MCF5271 Chip Errata

Silicon Revision: All

This document identifies implementation differences between the MCF5270 and MCF5271 processors and the description contained in the *MCF5271 ColdFire® Reference Manual*. Refer to <http://www.freescale.com/coldfire> for the latest updates.

Figure 1. Buffer Overrun Example

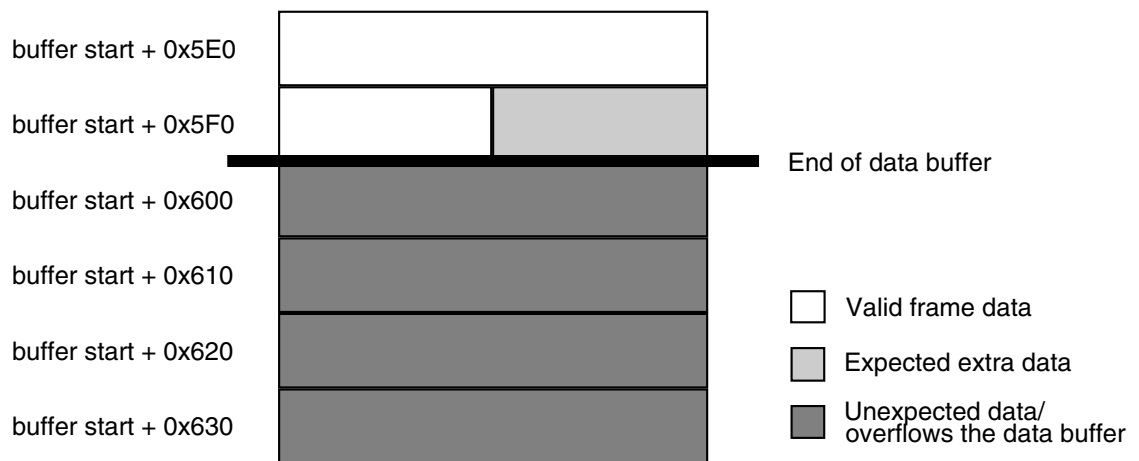
Description: When the FEC is connected to a 10BaseT network, if length of the data stored in a descriptor is not evenly divisible by 16 (not line-aligned), the FEC writes extra lines at the end of the buffer. The entire line that contains the last valid data is written and at least one extra line, but up to four lines after the end of the valid data can also be written. In most cases, this is not a problem because the extra lines of data continue falling within the limits of the buffer. However, if the valid data ends near the end of the buffer, the extra lines written by the FEC might be outside of the data buffer. This leads to corruption of the next buffer, descriptor, data, or code stored in the adjacent memory.

For example, as shown in the figure below, if the max buffer size is programmed to 0x600 and a frame that is 0x5F8 bytes long is received, a line is written starting at buffer start + 0x5F0. The first half of the line at buffer start + 0x5F0 is valid frame data that should be processed by the FEC driver; the second half of the line is additional data that is written because the FEC only writes complete lines. This data should be ignored by the FEC driver. So far, this is correct FEC behavior as originally specified. However, the FEC repeats the last line of valid data a number of times. The line at buffer start + 0x600 is written, and as many as three additional lines beyond the end of the data buffer could be written.

Workaround: Allocate extra lines for the receive data buffers. The actual allocated memory for each buffer should be equal to the receive buffer size programmed in the FEC's EMRBR register plus four lines (16 byte-sized lines).

Workaround: Program the data buffer size one line larger than the max packet size (data buffer size = EMRBR + 0x40).
